# City of Plymouth Planning Commission

## Regular Meeting Agenda

Wednesday, November 9, 2022 – 7:00 p.m.  
City Hall & Online Zoom Webinar

**Planned Unit Development  
For  
City of Plymouth, Michigan**

PULTE HOMES OF MICHIGAN, LLC  
PLYMOUTH MULTI-FAMILY  
AMENDED PUD PLAN  
UTILITY AND GRADING PLAN

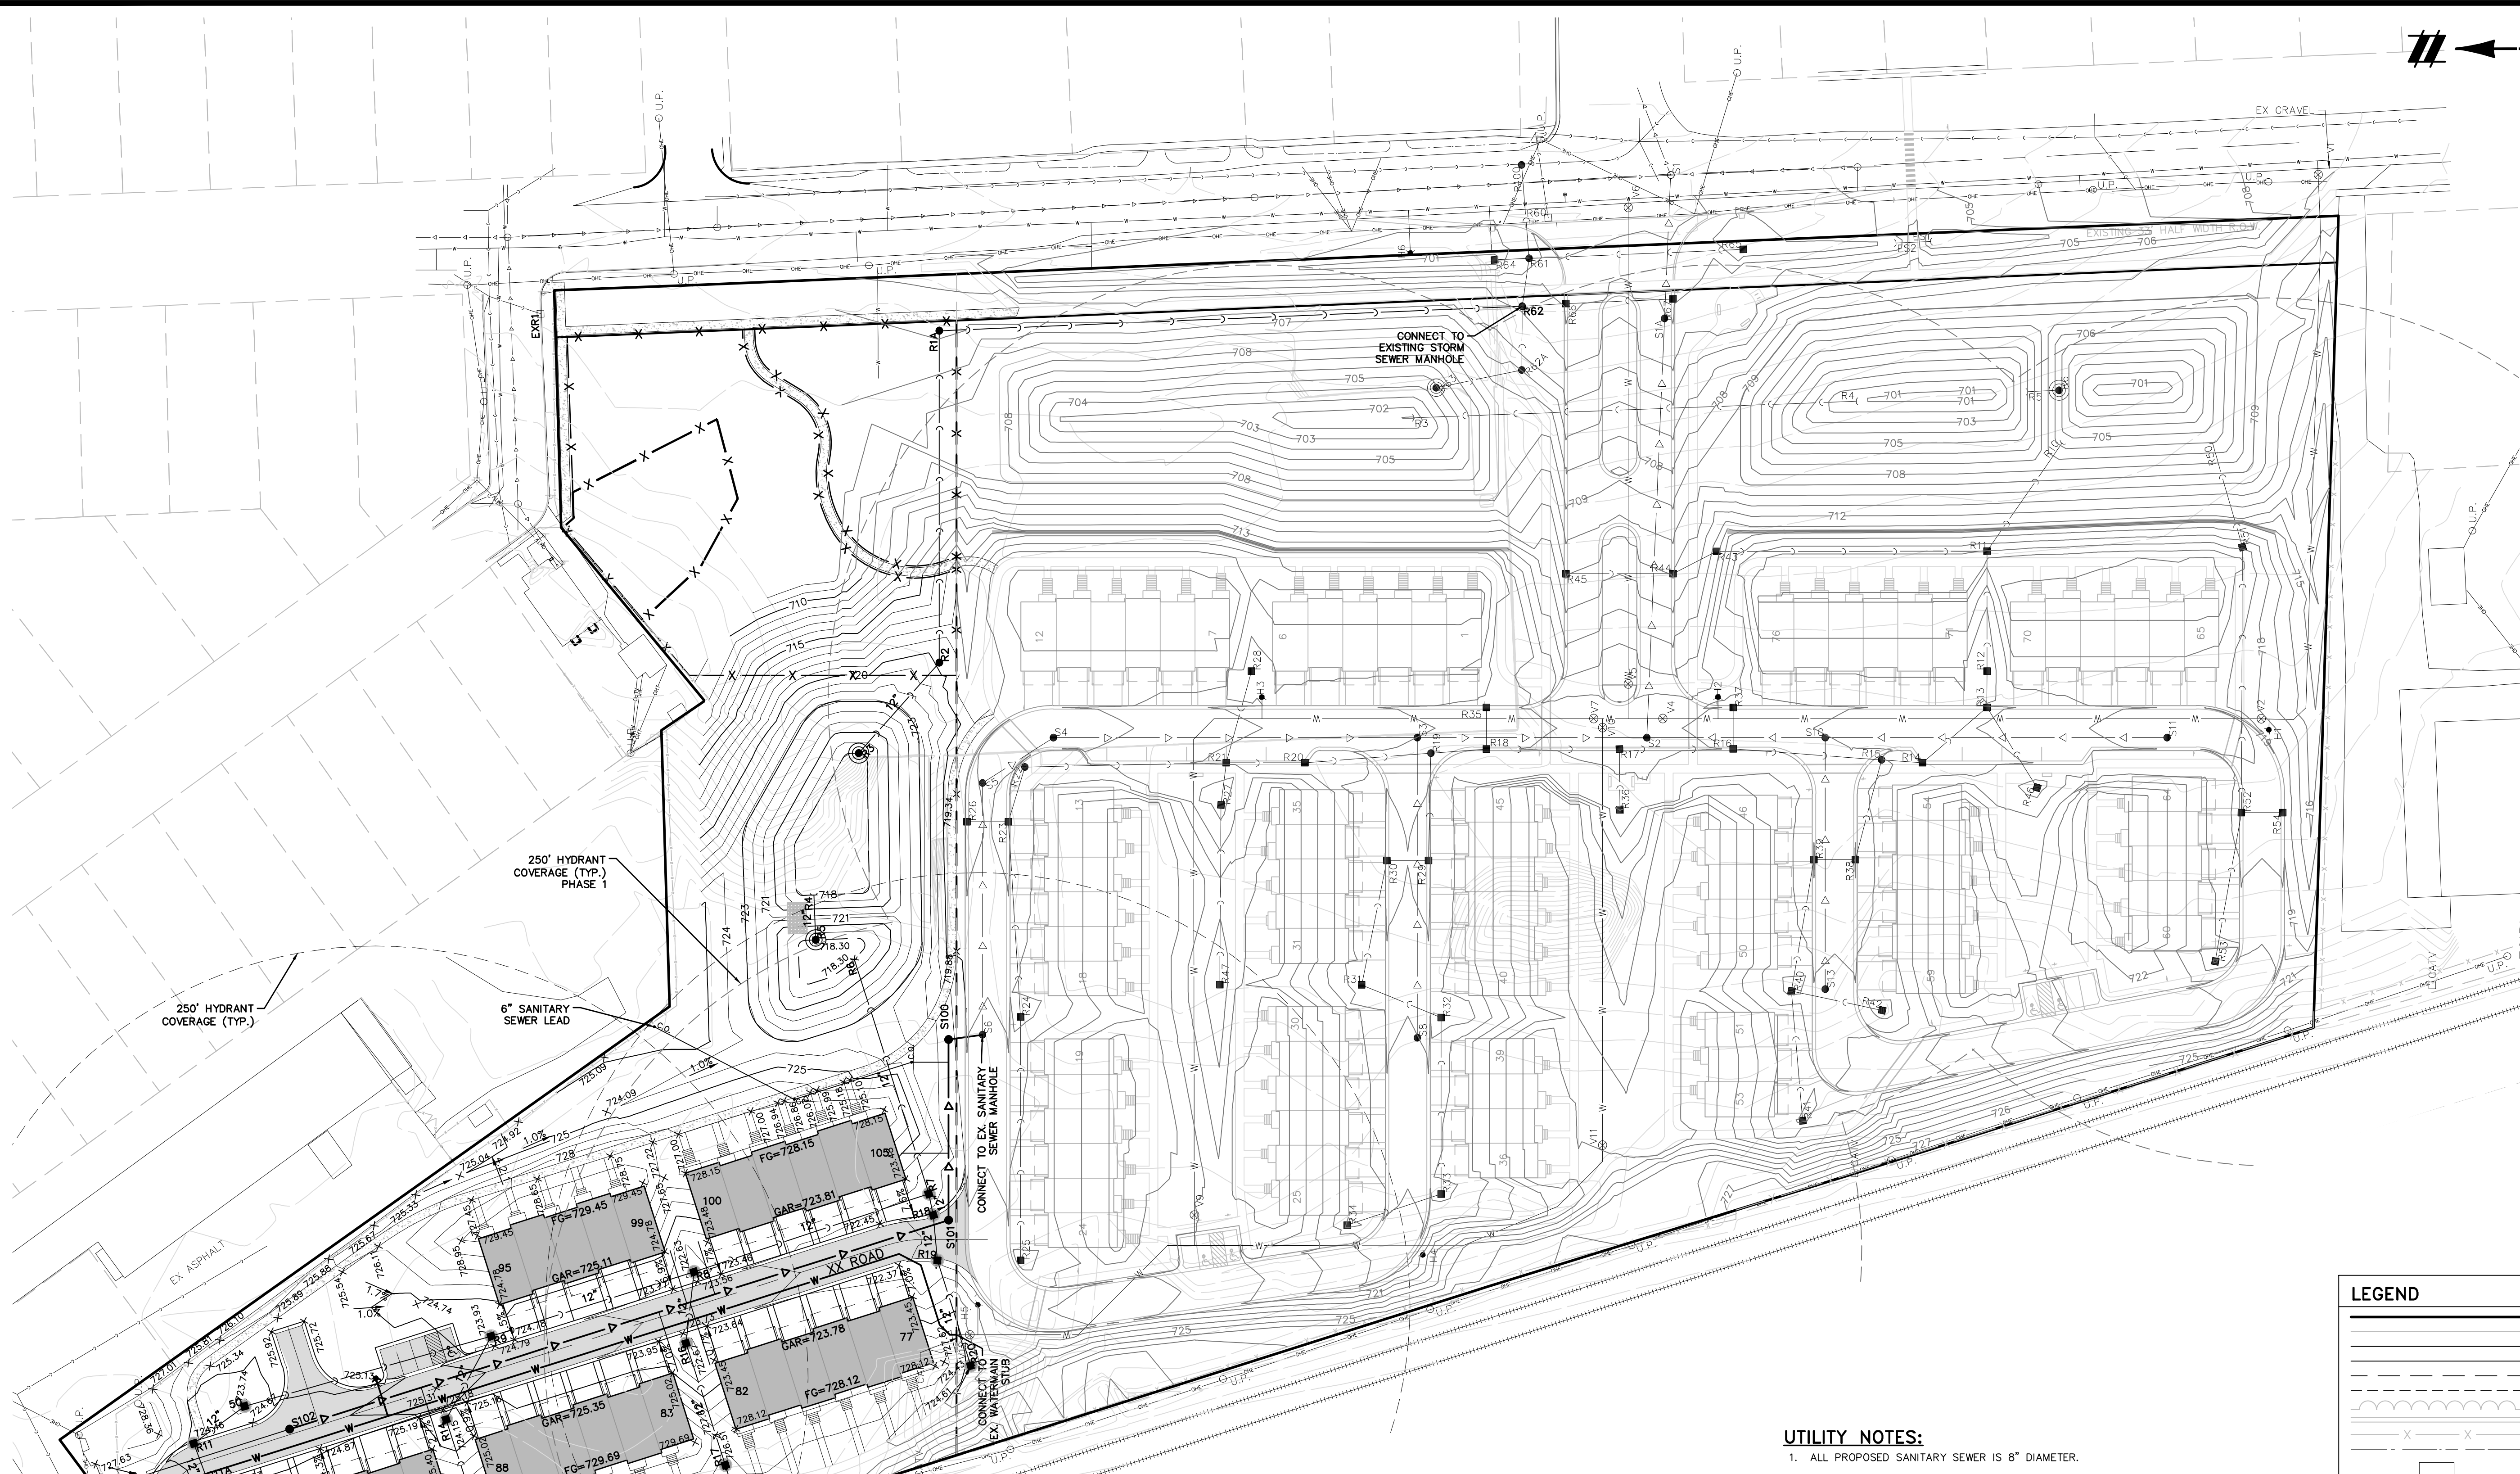
1. The proposed sanitary sewer shown on page 04 (Utility and Grading Plan) is proposed to connect to the public sanitary sewer available on N. Sydney Ct. (shown as Oliver in this plan set). There is available capacity in the public sanitary sewer along N. Sydney Ct and downstream along Sydney Blvd to accommodate the additional 29 townhomes that are proposed.

2. As an additional public benefit under the PUD, the developer should provide two sanitary sewer easements to the north to allow future connections to this public sanitary sewer. The two easements should run from the existing sanitary sewer to the properties with tax parcel identification numbers 49-005-01-0363-004 and 049-005-01-0362-007.

5. The plans propose the installation of a new 8-inch water main extension from the existing public water main on N. Sydney Ct. This new water main is proposed to dead end approximately 400 feet from the existing public water main installed during the initial phases of the Mill Towns project.

6. The Planning Commission should be aware that the residents along N. Sydney Ct. have been experiencing poor water quality (reduced chlorine residual) in the northwest corner of N. Sydney Ct. This condition has not been something that has been easy to fix even as additional users have been added to the system within the Mill Street Towns development. The city has received several complaints and currently has to flush the water system once a month by running water from the hydrants along this portion of the water system. One possible solution to this problem would be to loop the water system to the water main on Main Street.

7. We recommend that the developer provide a public water main easement (and potentially new water main) for a future connection to Main Street. The easement should be provided to the 49-005-01-0362-007 property. Ideally, we would want to see the developer include this connection to Main Street as part of this PUD Amendment to help solve the water quality problem.

**Response:** *Noted.*

**Response:** *The requested sanitary easements are now shown, as requested.*

**Response:** *Noted. No action required.*

**Response:** *Noted. See response to #7 below.*

**Response:** *The watermain and easement have been extended to the parcel's northern boundary to facilitate and future extension out to Main Street should the parcel to the north ever be redeveloped.*
